STAFF REPORT

SUBJECT: Windrow No. 3
FP-2026-0015

LOCATION: Generally located at the NEC of S. Linder Road and W. Amity Road (Parcels #S1225347078, #S1225325700, #S1225336520, #S1225336505., in the SW 1/4 of Section 25, T.3N., R.1W.

Final Plat consisting of thirty-seven (37) building lots and eight (8) common lots on 7.92 acres of land in the R-8 zoning district for the third phase of Windrow Neighborhood Subdivision.

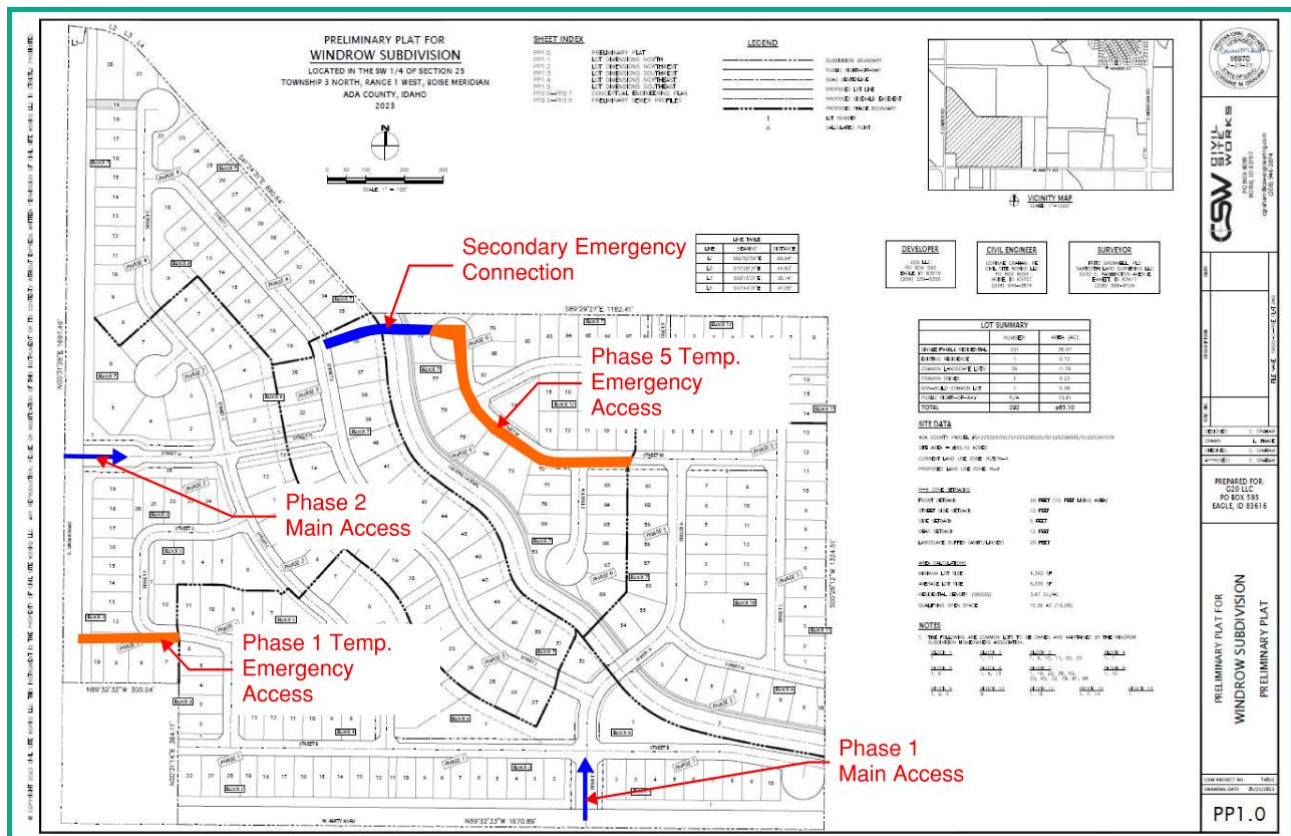
While the proposed final plat includes minor modifications to the road alignment and open space configuration, these changes do not affect overall compliance with the approved preliminary plat. Additionally, the applicant has reduced the number of buildable lots in this phase by one (1) compared to the preliminary plat. The applicant also revised the phasing plan to allow required access

Because the number of buildable lots has decreased by one (1) and the amount of common open space has increased slightly, staff finds that the proposed final plat remains in substantial compliance with the approved preliminary plat, as required.

B. Final Plat (dated: 5/06/26)

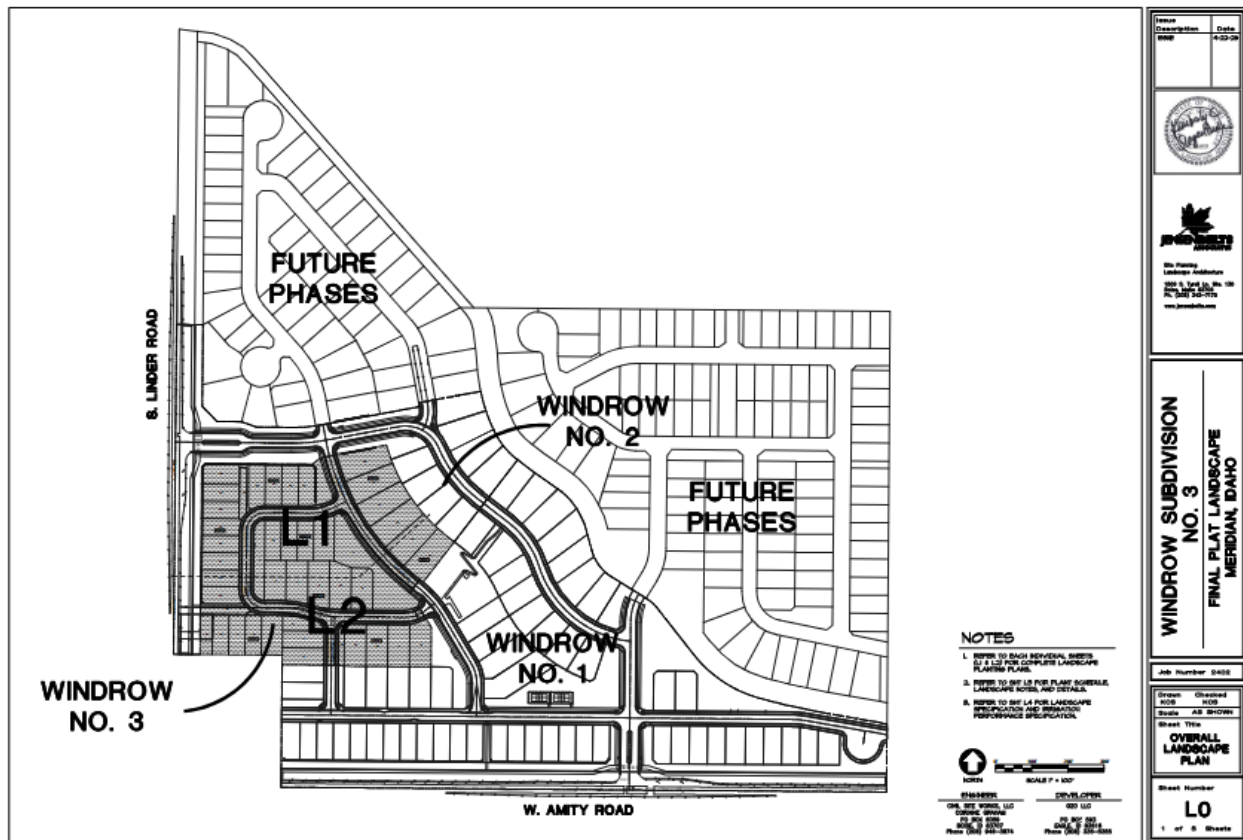
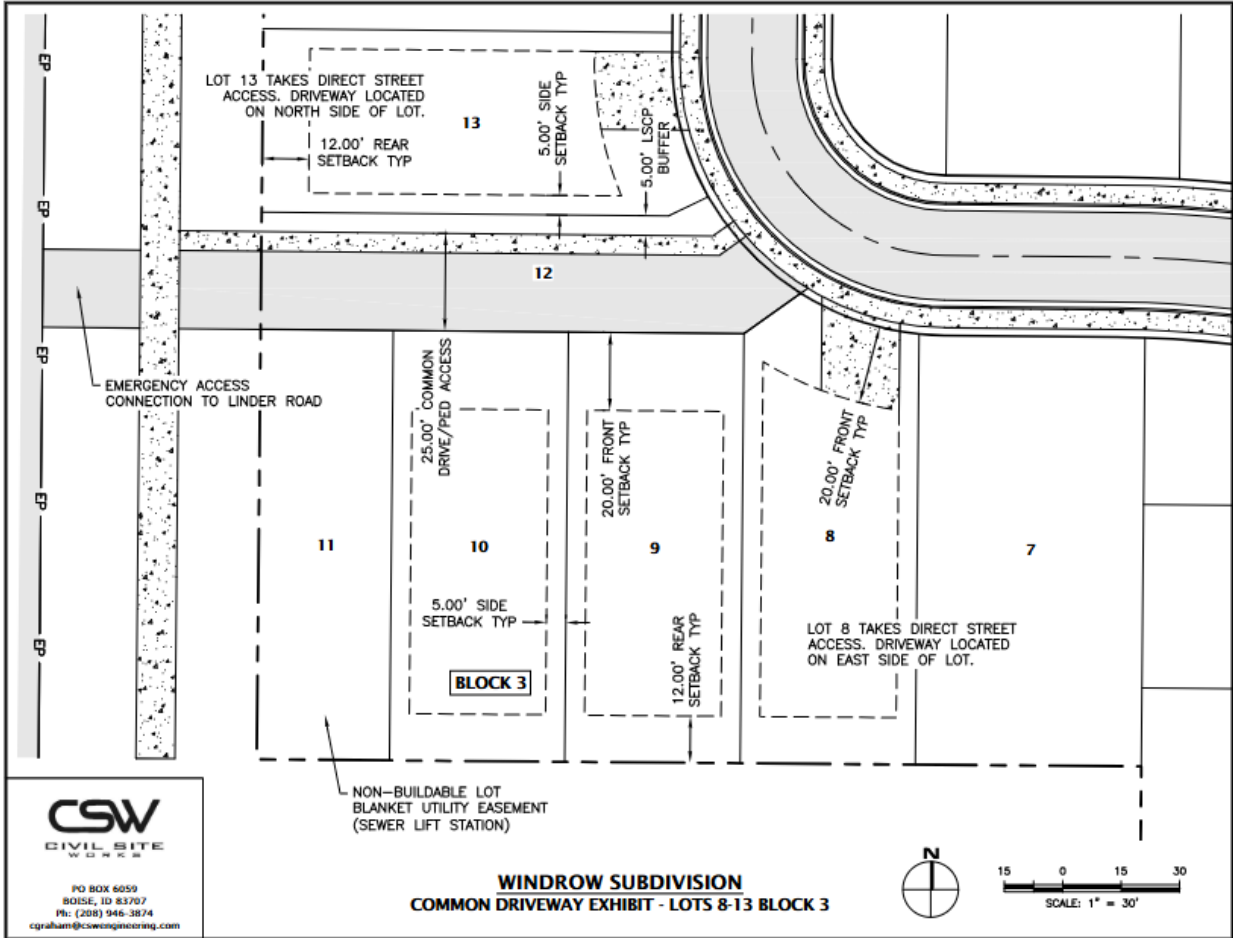
3. Prior to submittal for the City Engineer's signature, have the Certificate of Owners and the accompanying acknowledgement signed and notarized.
4. The final plat prepared by Civil Site Works, dated: 11/2/2023, included in Section V.B shall be revised as follows:
 - a. Note #6: Include the recorded instrument number for the ACHD license agreement.
 - b. Note #13: Include the recorded instrument number of the ACHD sidewalk easement.
 - c. Note #14: Include the recorded instrument number of the City of Meridian Sanitary Sewer Easement.
 - d. Confirm the fencing around the lift station is 6-foot closed vision fencing.
 - e. Confirm the type of traffic calming along Selawick Way.

A copy of the revised plat shall be submitted with the final plat for City Engineer signature.

C. Landscape Plan ((dated: 04/22/2026))

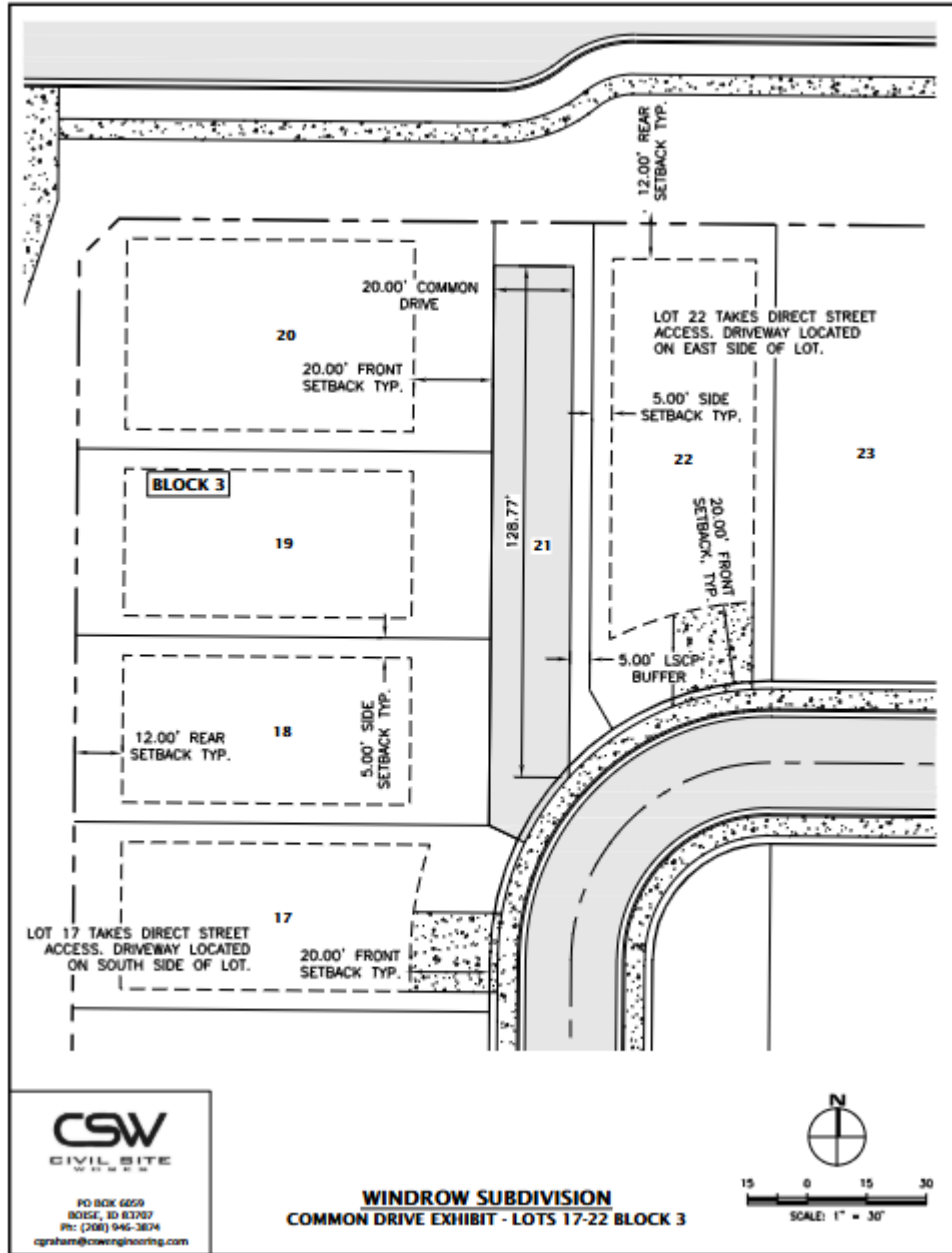
5. The landscape plan prepared by Jensen Belts, dated 4/22/2026, included in Section V.C, is approved as presented.
6. The rear and/or sides of home visible from S. Linder Road (Lots 11, 13-20, Block 3) shall incorporate articulation through changes in two or more of the following: modulation (e.g., projections, recesses, step-backs, pop-outs), bays, banding, porches, balconies, material types, or other integrated architectural elements to break up the monotonous wall plane and roof line that are visible from the subject public street. Single-story structures are exempt from this requirement.
